TECHNICAL GUIDANCE NOTE

Fire Risk Assessment of External Cladding Systems on High Rise Residential Building (Phase 3 Report)

Malin Apartments

Report date: 5th March 2020

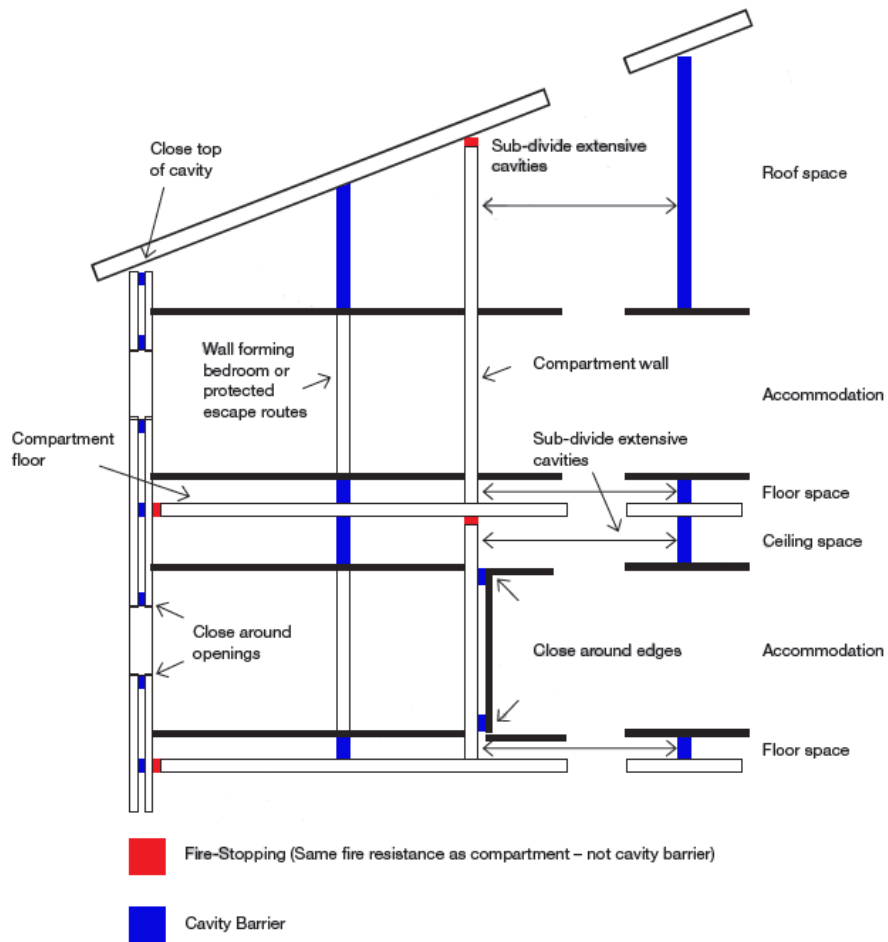
The spandrel panels (shown below) contain a man-made foam core, thought to be polyisocyanurate (PIR) foam.

Insulation found behind the spandrel panels was a mineral/glass wool quilt.

The use of PIR foam in the spandrel panels is also non-compliant. These would meet the Class 0 requirement under the 2010 guidance but not the limited combustibility requirement for a building over 18m.

Provisions for Cavity Barriers

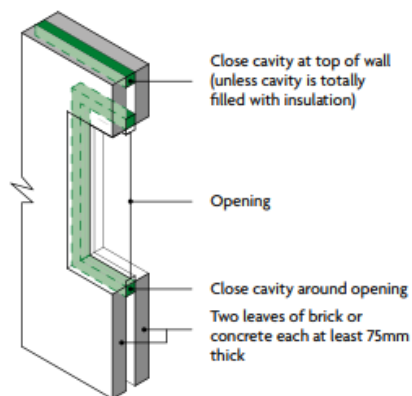
Cavity barriers were found at horizontal levels and at vertical compartment walls in the insulated render system cavity. Cavity barriers were not seen around openings in the render system as required (see diagram above), although this is unlikely to have been a specific requirement of the manufacturer’s guidance at the time of construction.

However, the barriers are not full thickness since the polystyrene is 120mm deep and the cavity barrier 100mm leaving a 20mm gap to the rear of the barrier, so an intumescent strip is provided behind the insulation.

Provide cavity barriers around all windows.
